1.1 ADDENDUM FORM

END OF ADDENDUM NUMBER NO. 1

5101 50th Avenue, Yellowknife, NWT

1 PARTIAL 4TH FLOOR PLAN (NORTH)
AD1.1 1 : 100

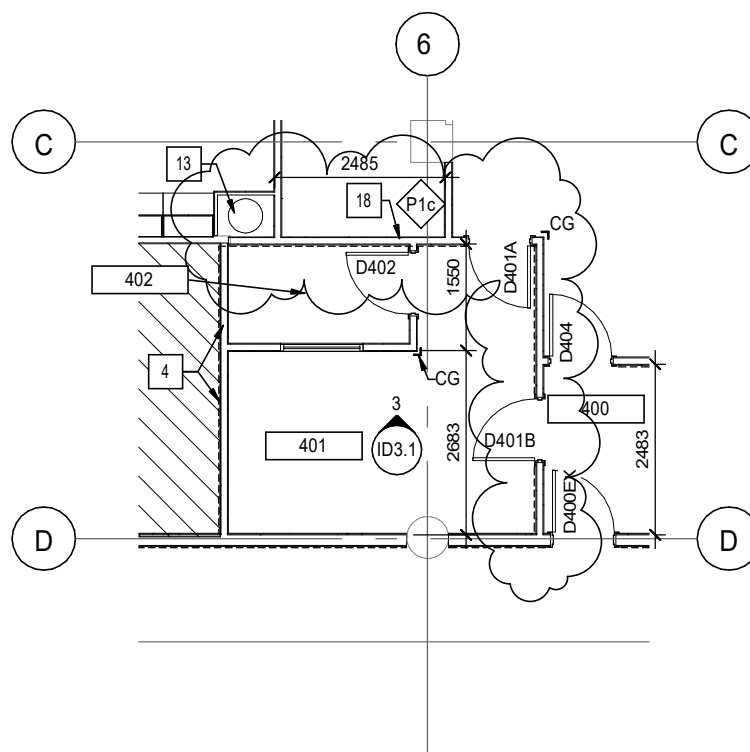
.1 DRAWING ID2.1, Detail 1

.1 Refer to attached detail drawing AD1.1: **Revise** location of wire mesh placement.

Steel Mesh Ceiling Detail

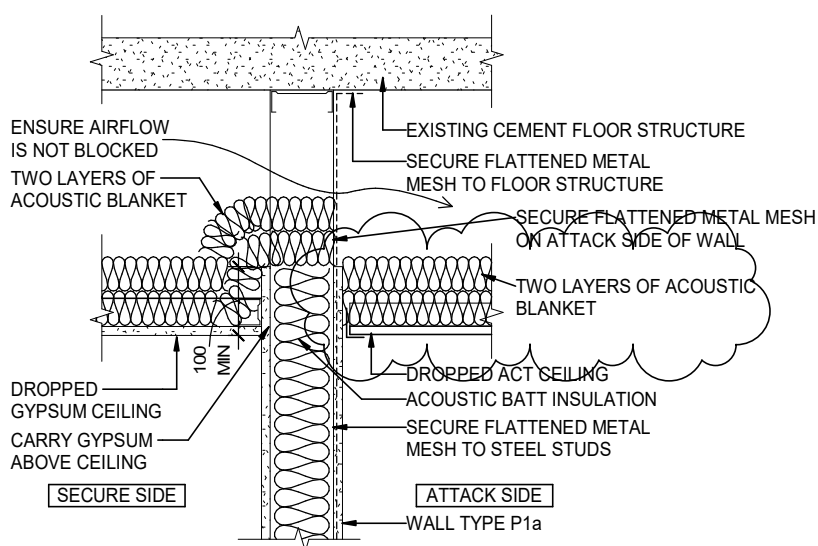
.3 DRAWING ID2.2, Detail 3

.1 Refer to attached detail drawing AD1.2: **Revise** to 1220 mm of acoustic blanket along secure wall above acoustic ceiling tile.

1
AD1.4
DETAIL OF DOOR GLAZING
1 : 5

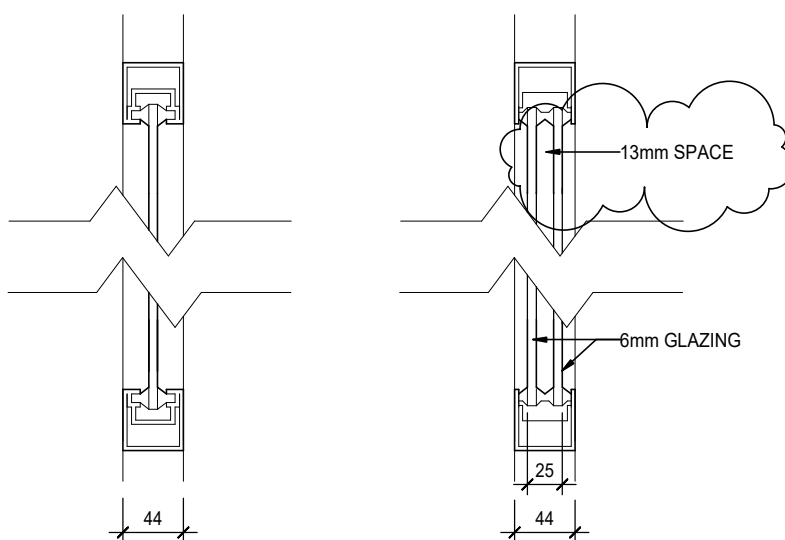
.4 DRAWING ID4.3, Detail 1

.1 **Revise** drawing to indicate 13 mm spacer in glazing unit.
